20-COA-0185
500 W. Ormsby Ave.

Old Louisville Architectural Review Committee
Public Hearing

Bradley Fister, Historic Preservation Specialist
February 17, 2021

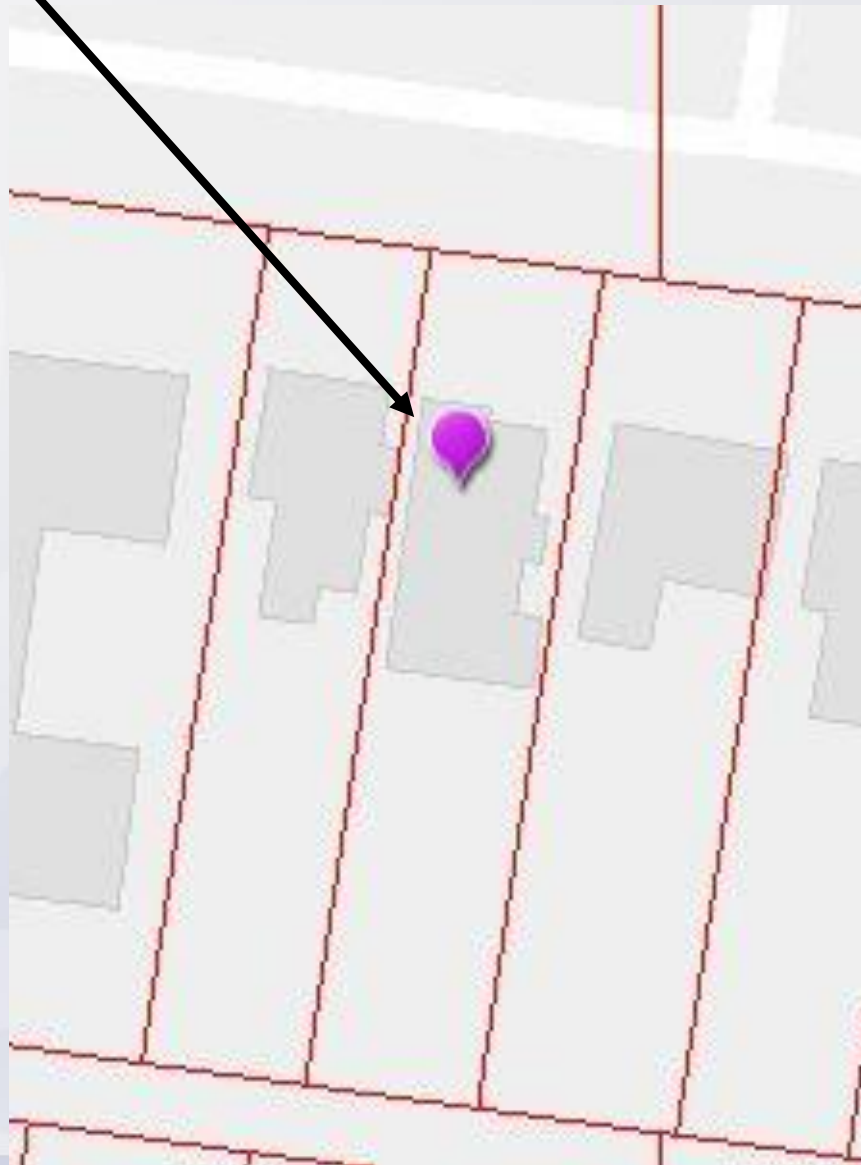
1. The applicant seeks after-the-fact approval for the replacement of 32 previously replaced windows in the building with vinyl windows. The single double-hung window on the front façade had not been replaced previously and has been replaced with two vinyl double-hung windows.

2. The applicant also seeks approval to repair / replace the wooden porch beam, and the repair and replacement of the cornice, frieze, and architrave with in-kind materials. This work would typically fall under general maintenance and would not require a Certificate of Appropriateness.

Site Photos

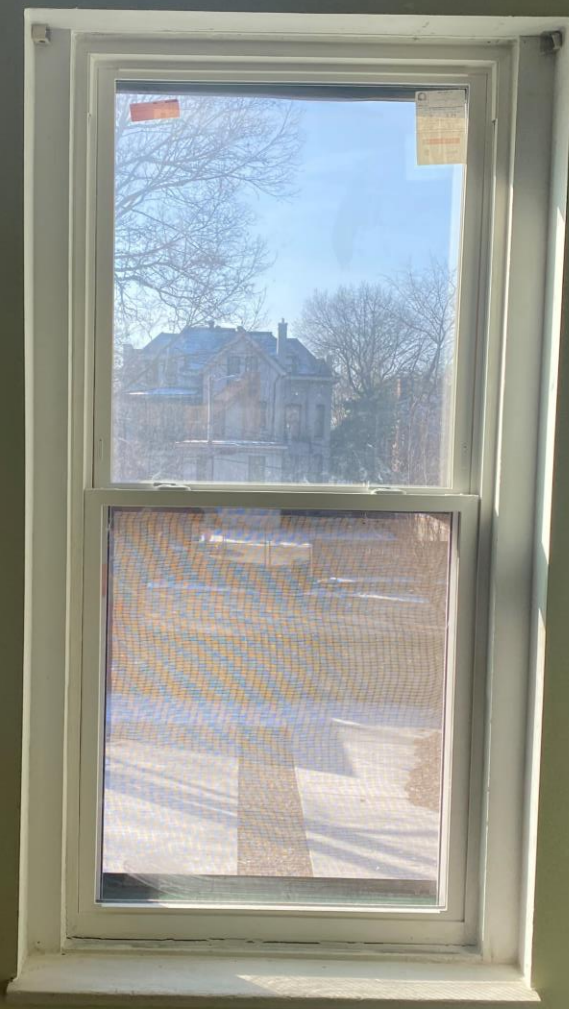
- The after-the-fact replacement windows generally do not meet the **Window Design Guidelines** for Old Louisville. The large one-over-one double-hung wood window on the front façade has been replaced with two vinyl one-over-one double-hung windows. Staff is unable to recommend the after-the-fact proposal for the vinyl windows per **W6** and **W7** for the front façade, as well as **W14** which states not to alter the number, size, location, or shape of original windows seen from a public way.

- While the new replacement windows do replicate the configuration of the previous replacement wood windows that had been installed previously without a COA, they are vinyl units. It appears that the window openings had been altered by decreasing the openings to allow for stock size windows. This is in direct conflict with **W4** which states that window openings should never be filled in to allow for stock windows.

Based on the information furnished by the applicant, staff recommends that the application for a Certificate of Appropriateness be **denied** for the after-the-fact window replacement for the front façade, first floor window from one window to two windows.

Based on the information furnished by the applicant, staff recommends that the application for a Certificate of Appropriateness be **approved with the following conditions** for the rest of the after-the-fact replacement windows on the front, sides, and rear facades.

1. The two first floor front replacement windows that have been put into what was previously the opening for a single double-hung window, shall be replaced with a wood window that both fits the historic window opening, and original window configuration.
2. All other windows appear to have been previously replaced or altered and no longer have historic integrity, should these be changed again in the future the applicant shall notify staff prior to work being done.
